**COMPREHENSIVE
CITY PLANNING CALENDAR
of
The City of New York**

WEDNESDAY, FEBRUARY 18, 2009

IN THE MATTER OF an application submitted by the Department of City Planning pursuant to Section 201 of the New York City Charter, **for an amendment of the Zoning Resolution** of the City of New York, relating to modifications of Article VI, Chapter 2 (Special Regulations Applying in the Waterfront Area); and various related Sections of the Zoning Resolution.

Requirements for Public Access on Piers (moved from 62-412)

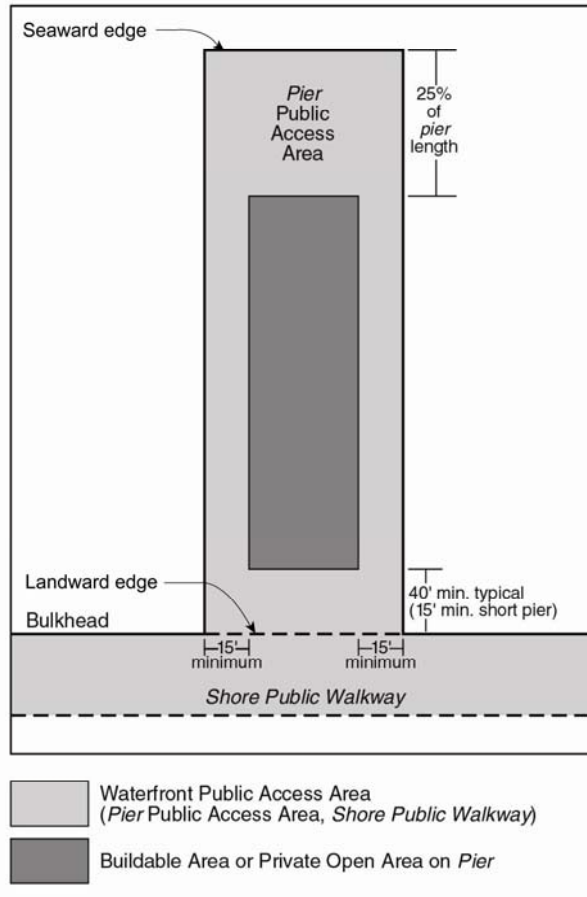
(delete existing graphic – insert new)

#Waterfront public access areas# on #piers# shall consist of the following:

- (a) an area along the seaward edge of the #pier# having a depth measured from such edge equal to at least 25 percent of the total length of the #pier#. Building projections into such required public access area are permitted provided that the aggregate width of all projections at the level of any #story# does not exceed 50 percent of the aggregate width of the #building#. Such projections shall not reduce the depth of the required area by more than 20 percent and shall not be included in the computation of public access area provided on the #pier#. In no event shall the depth of the public access area be less than 15 feet;

Illustration A1

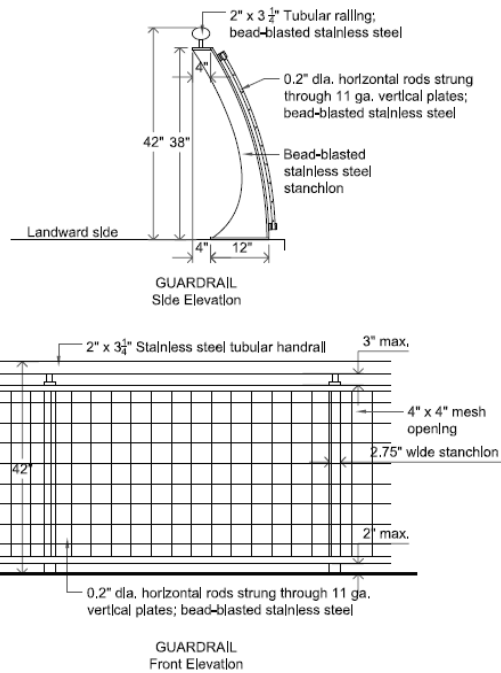
~~Illustration A1
(delete existing illustration)~~

All guardrail components and hardware shall be #316 stainless steel passivated and bead blasted. ~~or cast aluminum, as applicable.~~

Illustration B1

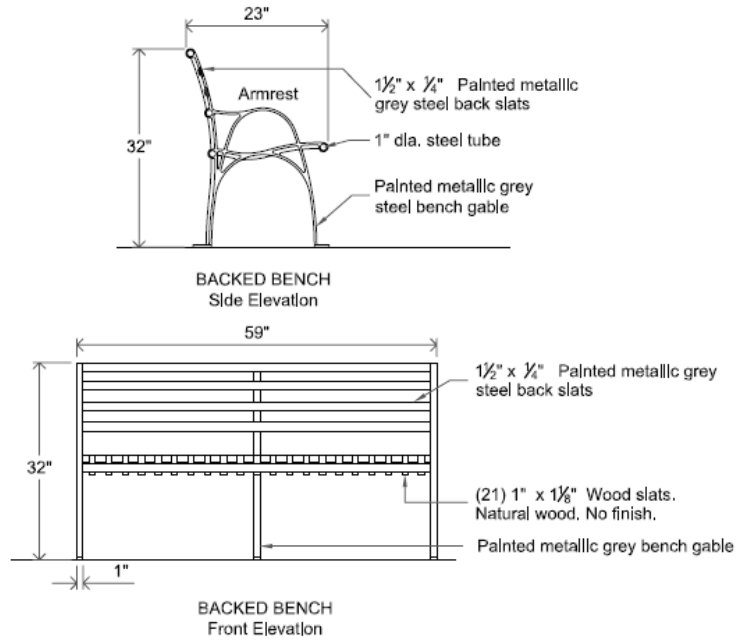
~~Illustration B1~~
(delete existing illustration)

Illustration B2

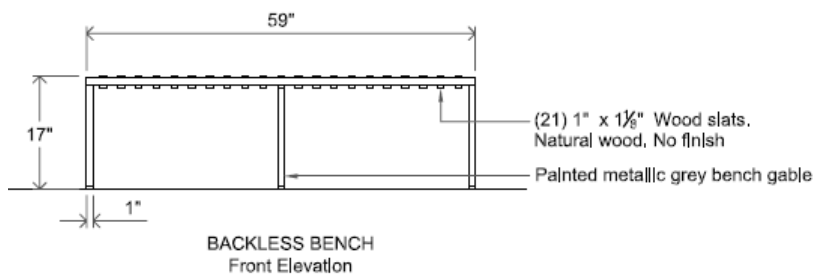
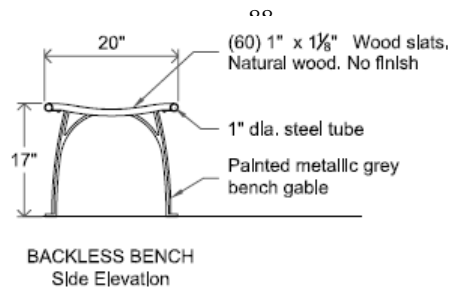
~~Illustration B2~~
(delete existing illustration)

All wood boards shall be made of domestically grown non-tropical hardwoods, such as American White Oak (Quercus alba), redwood, jarrah or ipe, have eased edges and ends and be treated for external use without stain or varnish.

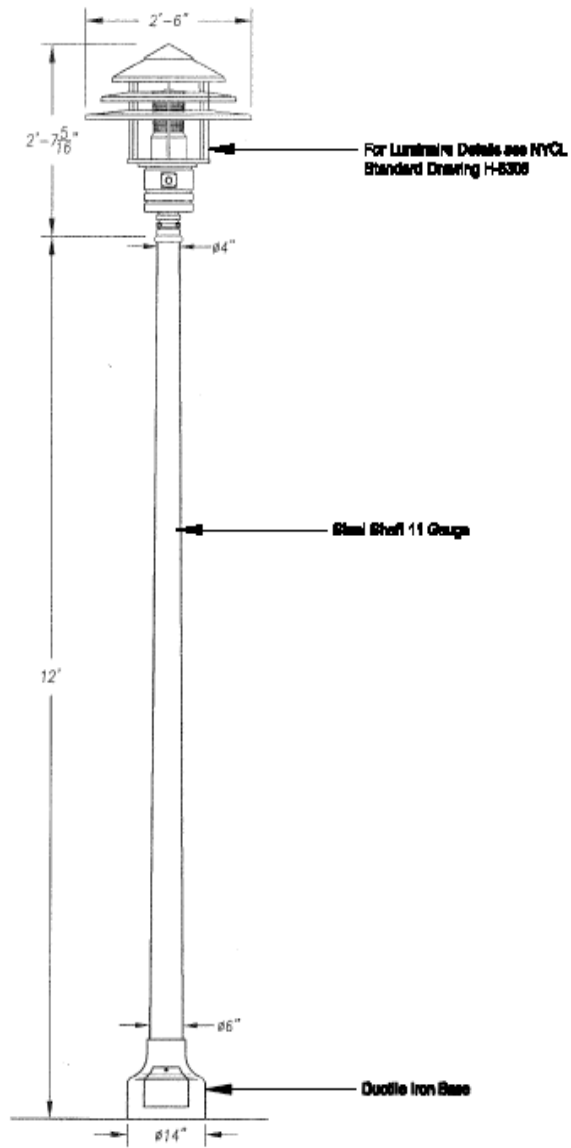
~~All supports and backstraps shall be 713 tenz alloy cast aluminum, with a rust inhibitor and a top coat finish of thermosetting polyester powdercoat that is ultra violet, chip and flake resistant. Metal components shall have a light gray or aluminum color.~~
